# **AVANTERRA BLACK FOREST FINAL DRAINAGE REPORT AMENDMENT**

## **AMENDMENT TO: MASTER DEVELOPMENT DRAINAGE PLAN FOR WOODMEN HEIGHTS MASTER PLAN**

SWENT Project No. STM-REV23-0541  
Bowman Job No. 020439-01-003  
**June 2023**

The purpose of this report is to amend certain inlet types and locations and certain public storm sewers from the “Avanterra Black Forest Final Drainage Report – Amendment To: Master Development Drainage Plan for Woodmen Heights Master Plan”, prepared by Bowman and approved on October 25, 2022, and to provide relevant updated hydraulic calculations. There are no changes proposed to the drainage basin boundaries, impervious areas, or peak flows included in the previously approved Final Drainage Report.

**PROPOSED DRAINAGE MAP**

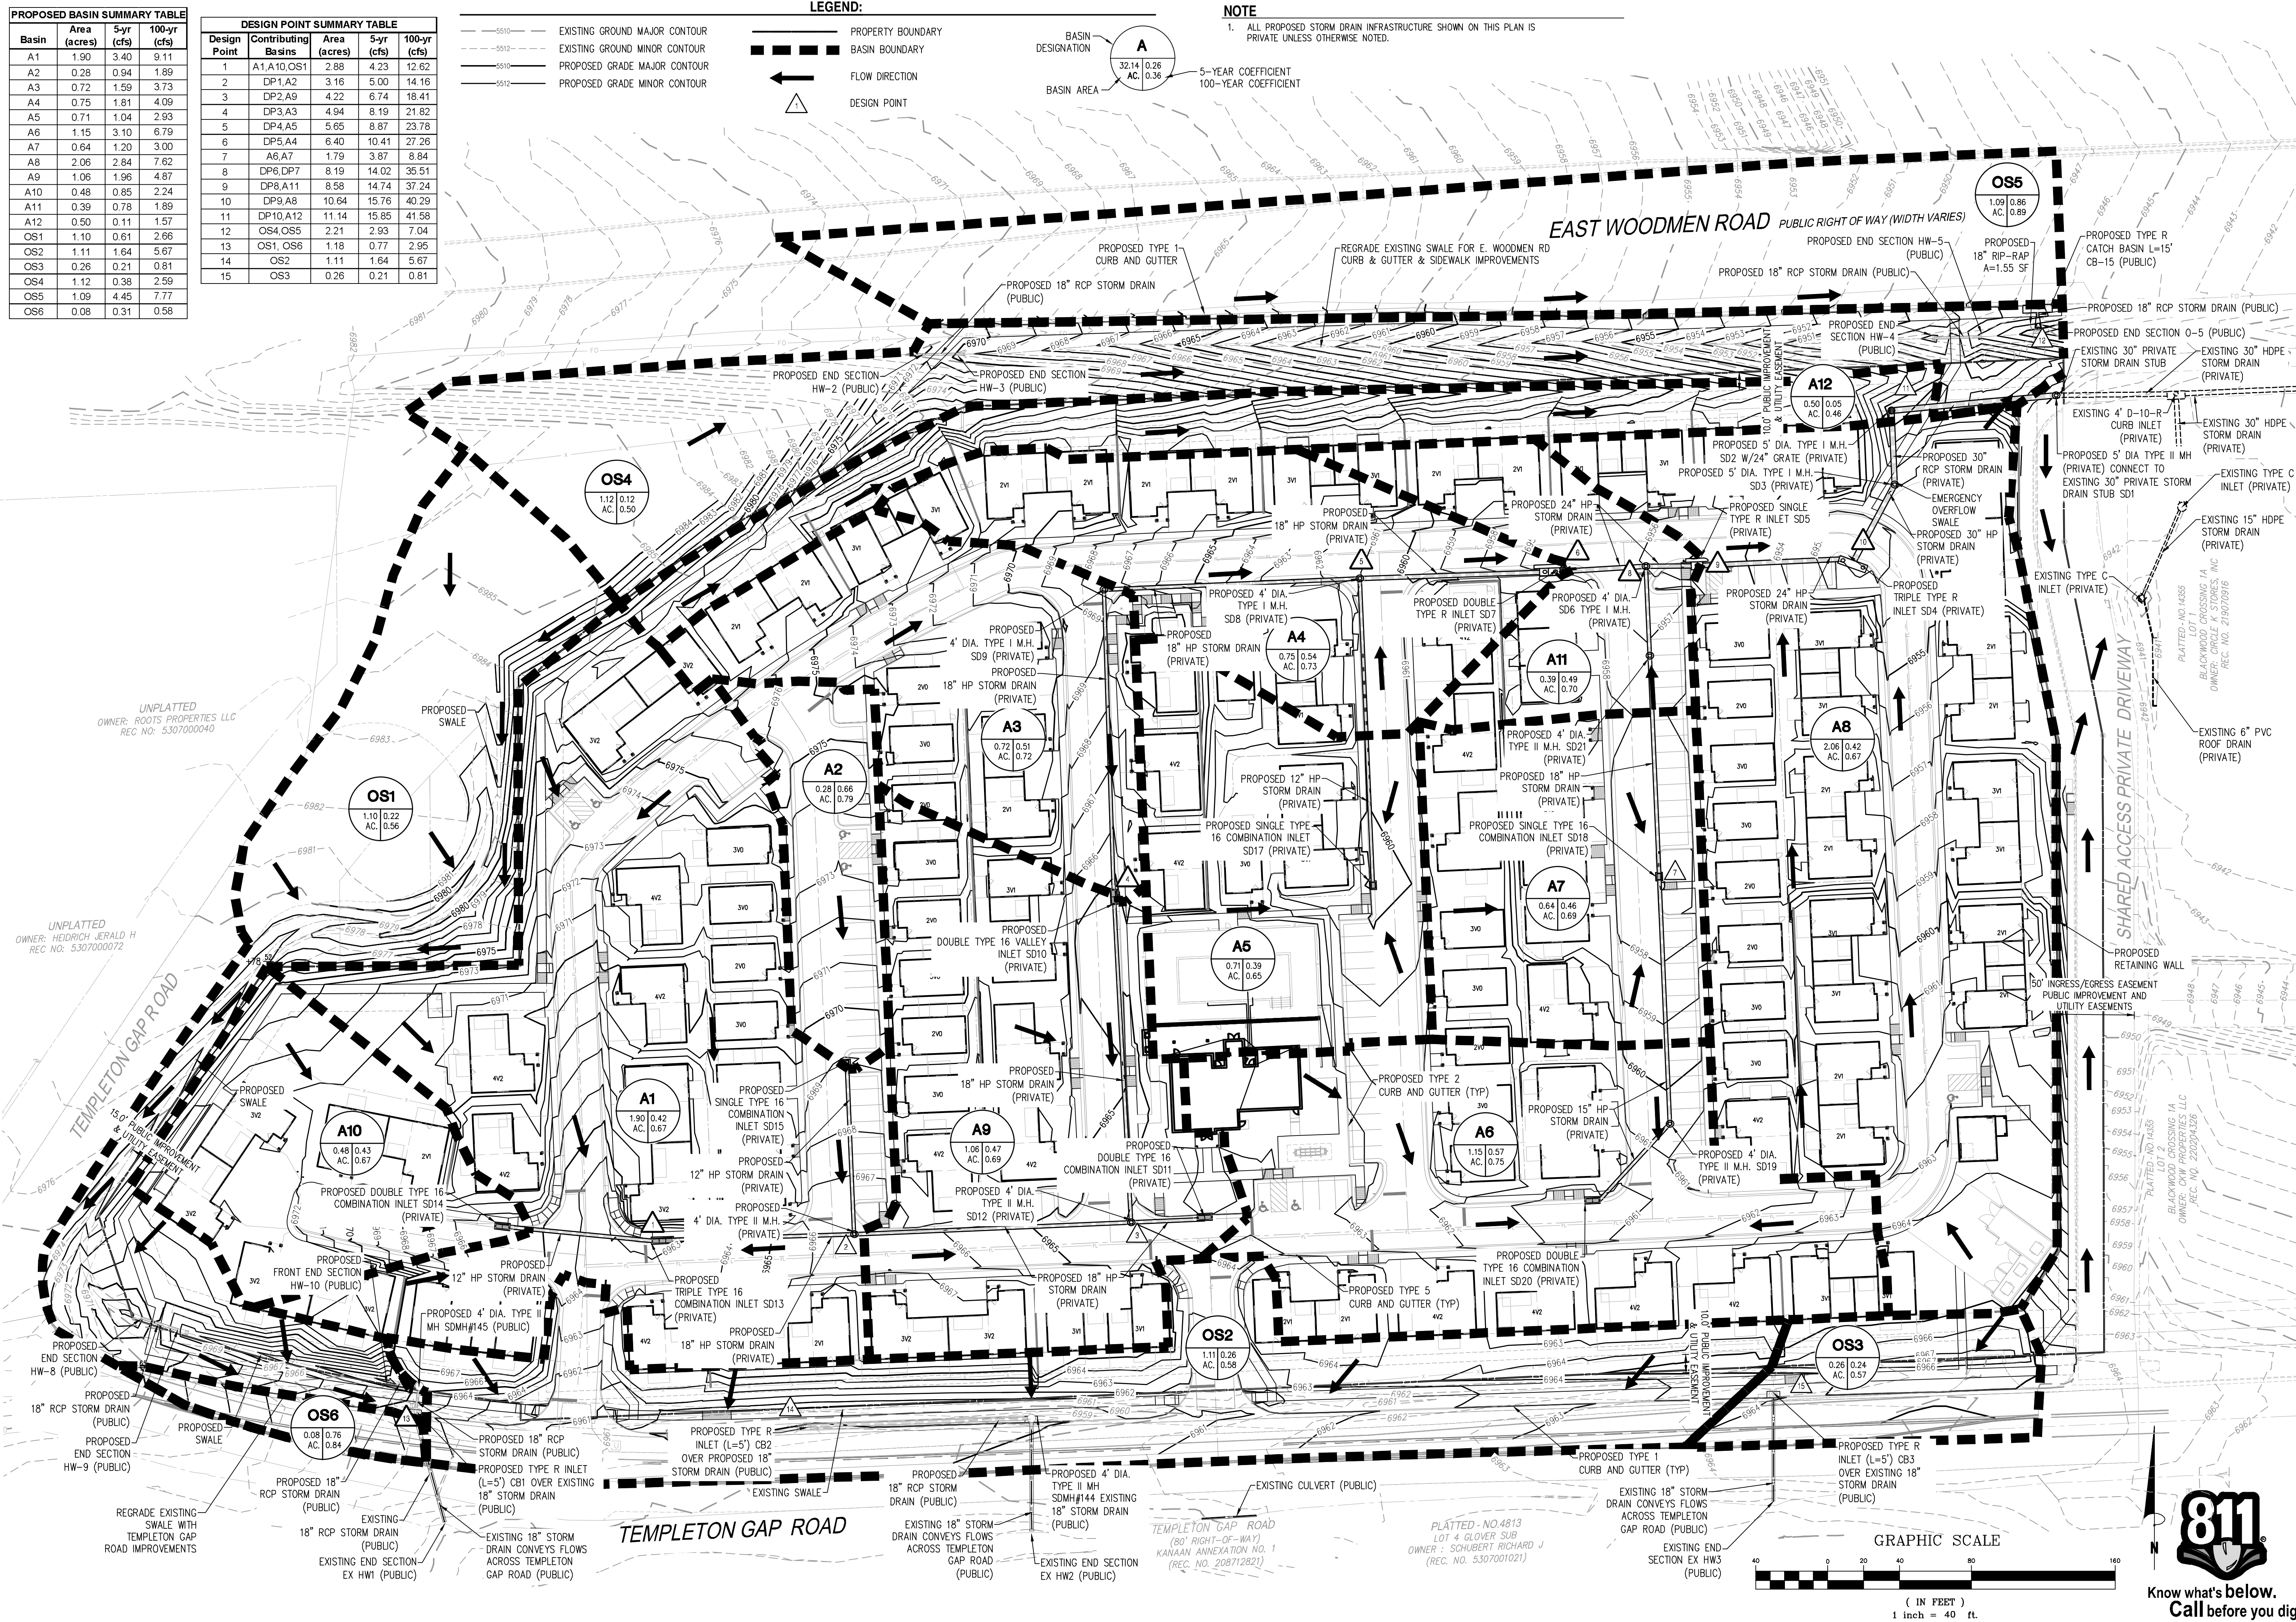
- **Revised Report Sections:** 1 Purpose, 3.2 Subbasin Descriptions, 5.3 Drainage Fees, 5.4 Erosion Control Design, 5.5 Construction Cost Opinion, 6 Summary
- **Revised Inlet Types:** A3, A4, A8, A11
- **Revised Culverts:** Increased pipe size from 12” to 18” on the following culverts:
  - HW-8 to HW-9
  - HW-2 to HW-3
  - HW-4 to HW-5
- **Revised Appendices:** Proposed Drainage Basin Map, Inlet Calculations, and Hydraulic Calculations (StormCAD Model Results)

On the previous report, this inlet was shown as an on-grade double Type 16 combination inlet. This has been revised to a double Type 16 valley inlet due to a driveway conflict and has been corrected to be in-sump based on the approved grading. The new inlet still has sufficient capacity for this subbasin during the minor and major design storm events.

On the previous report, this inlet was shown as a double Type 16 combination inlet. This has been revised to a double Type R inlet due to construction availability and was shifted slightly to be off the curb radius. The new inlet has a greater capacity with less bypass flow and only a small amount of bypass in the major storm event that is flowing to Basin A11.

On the previous report, this inlet was shown as a double Type 16 combination inlet. This has been revised to a triple Type R inlet due to construction availability and shifted around the curb radius. The new inlet has sufficient capacity for the major and minor storm events.

On the previous report, this inlet was shown as a double Type 16 combination inlet. Due to limited space and conflicts with the proposed sidewalk and parking, this inlet was reduced to a single Type R inlet. The inlet still has full capacity for the minor storm event, but the bypass flow in the major storm event increased slightly and will flow to Basin A8 which has sufficient capacity for the basin and bypass flows. This basin/inlet takes overflow from Inlet A4 which is in Basin A4.

The only change to the previous report is to upsize the culvert from a 12" to an 18" pipe.

The only change to the previous report is to upsize the culvert from a 12” to an 18” pipe.

**STORMCAD EXHIBIT**  
 AVANTERRA BLACK FOREST  
 DEVELOPMENT PLAN  
 EAST WOODMEN ROAD AND TEMPLETON GAP ROAD  
 COLORADO SPRINGS COLORADO

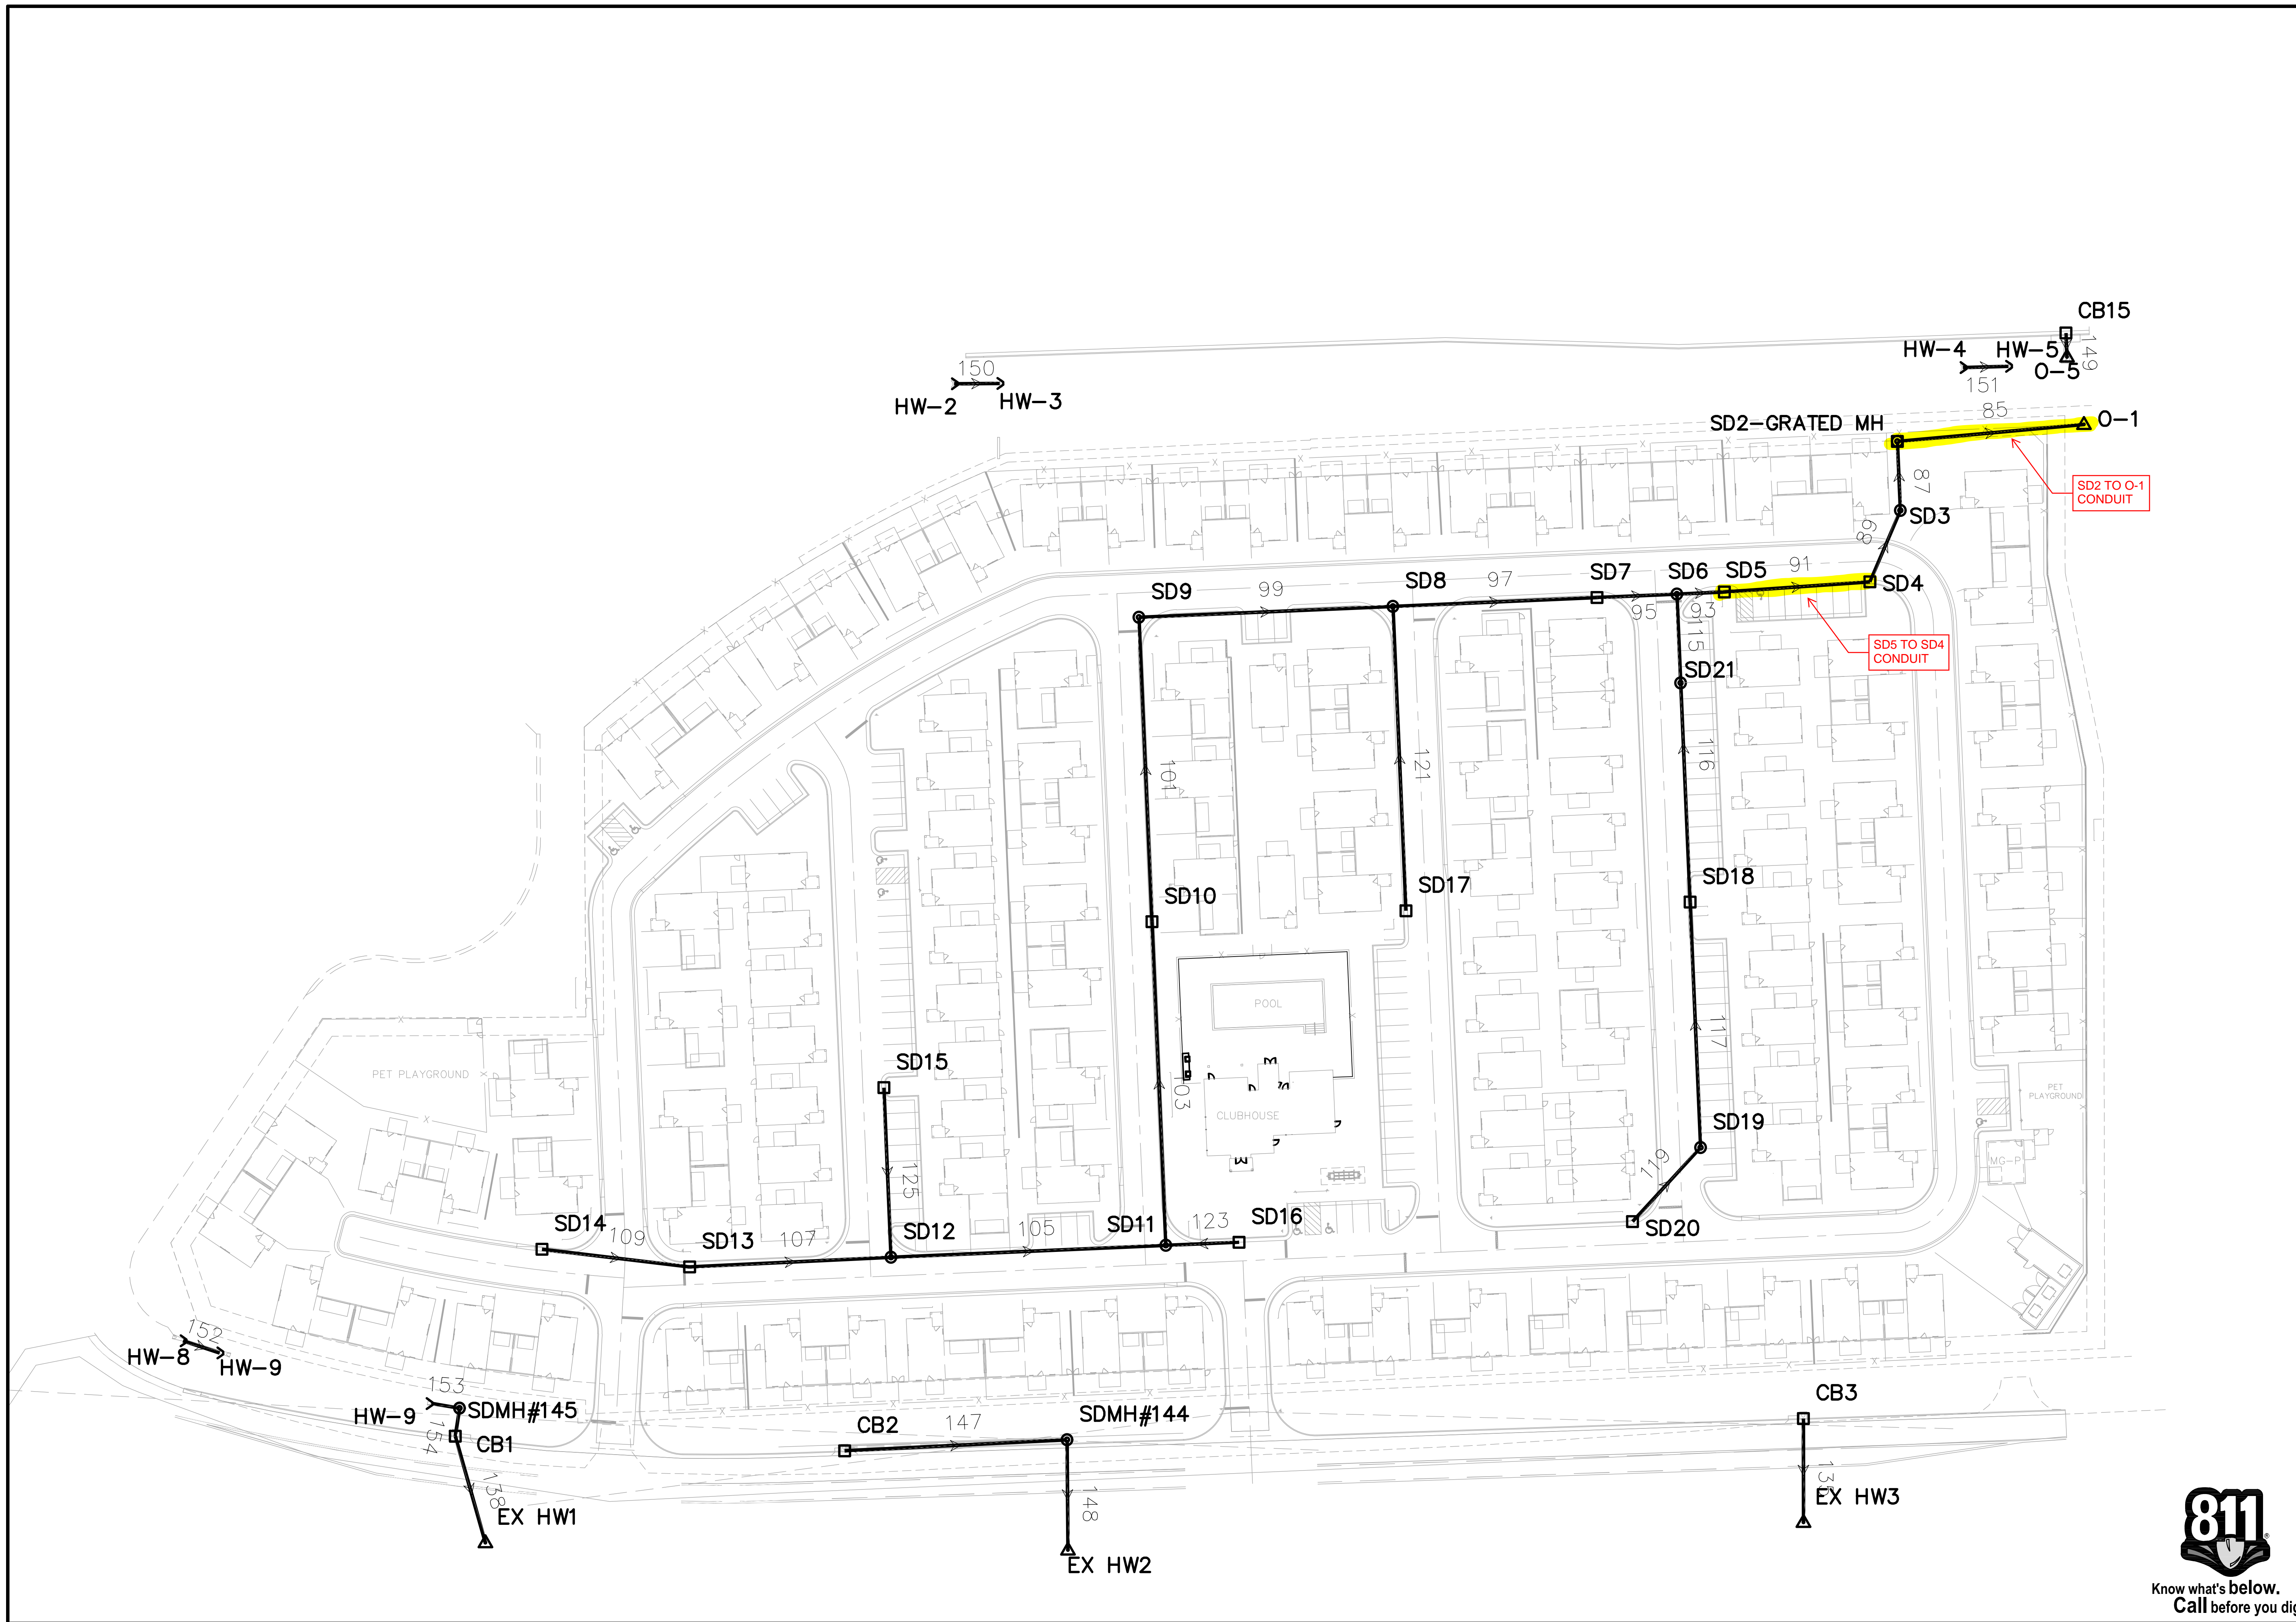
- Per the DCM Volume 1, Chapter 9, Section 7.1.1, "...the maximum velocity in all storm sewers shall be limited to 18 feet per second (ft/sec) for all design flows."
- We are requesting a variance to allow a velocity of greater than 18 feet per second within the proposed storm sewers due to two of the conduits having a modeled velocity above 18 ft/sec in the 100-year storm event.

As discussed in the approved Final Drainage Report, the proposed storm sewer ties into an existing 30" storm sewer stubbed out to the site at the northeast corner of the tract. Per the "Preliminary and Final Drainage Report for Blackwood Crossing Filing No. 1A", this stub out was sized for a peak flow of 50 CFS in the 100-year storm event which is greater than our proposed peak flow at the connection. Due to the high elevation difference between our site and the storm sewer stub-out, we had to use steeper pipe runs in

order to connect to the existing invert, which caused high velocities in certain pipes. Because the downstream pipe was sufficiently sized for our proposed flows and the storm sewer run to the Sand Creek Regional Detention Facility No. 6 is over 1,100 LF from our point of connection, it is our professional engineering opinion that the approval of this variance will not adversely impact the downstream storm sewer system or properties within the design storm events. If granted, this variance will not result in any increase in peak flows, nor will it result in any decrease in water quality in Fountain Creek. This variance will not negate the minimum requirements of the City of Colorado Springs Drainage Criteria Manual Four Step Process.
